Access Compliance Report

(Curb Ramps)

Intersection ID: 10021729	Main Street: BRIANNA_WY	Cross Street: N/A	Location: E
ADA ID: B338D7ACF4E7	Ramp Type: Perp	Initial Pass/Fail: Fail	Overall Compliance: No
Severity Score: 8.75			
Codes/Mitigation Info/Possible Solution		Field Measurements/Component Compliance

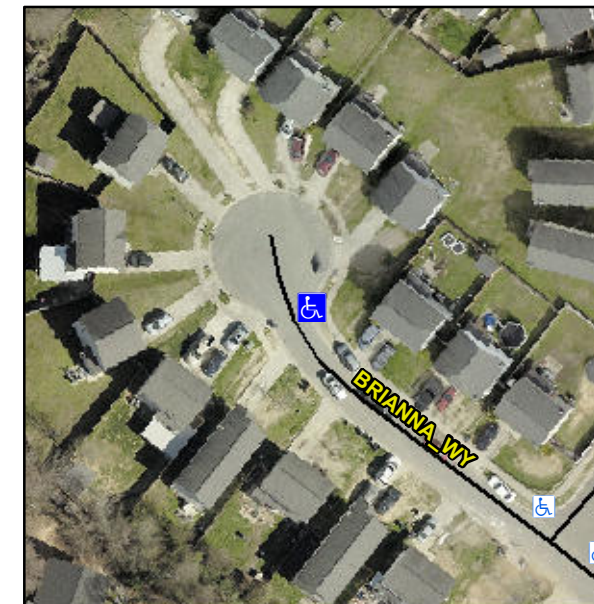
Not Found, R304.5.1

Compliance	Description	Data	Compliance	Description	Data
N/A	Ramp Length (in)	46.0	Yes	Ramp Slope (%)	7.1
No	Ramp Width (in)	39.0	Yes	Ramp XSlope (%)	1.8
N/A	Flare Type LT	N/A	N/A	Flare Type RT	N/A
N/A	Flare Slope LT (%)	N/A	N/A	Flare Slope RT (%)	N/A
N/A	Flare Traversable LT?	N/A	N/A	Flare Traversable RT?	N/A
N/A	Landing Length (in)	N/A	N/A	DWS Provided?	N/A
N/A	Landing Width (in)	N/A	N/A	DWS Contrast?	N/A
N/A	Landing Slope (%)	N/A	N/A	DWS Length (in)	N/A
N/A	Landing X Slope (%)	N/A	N/A	DWS Full Width?	N/A
N/A	Landing Curb? (Y/N)	N/A	N/A	DWS Offset (in)	N/A
N/A	Shared Landing?	N/A			
N/A	Gutter Ponding?	N/A	N/A	Gutter Slope (%)	N/A
N/A	Gutter Lip Ht (in)	N/A	N/A	Gutter X Slope (%)	N/A
N/A	Painted X Walk1?	No	N/A	Painted X Walk2?	N/A
	X Walk 1 Direction	To W		X Walk 2 Direction	N/A
N/A	X Walk 1 Width (in)	N/A	N/A	X Walk 2 Width (in)	N/A
	X Walk 1 Slope (%)	1.3		X Walk 2 Slope (%)	N/A
	X Walk 1 X Slope (%)	2.4		X Walk 2 X Slope (%)	N/A

Remove & Replace Entire Ramp.
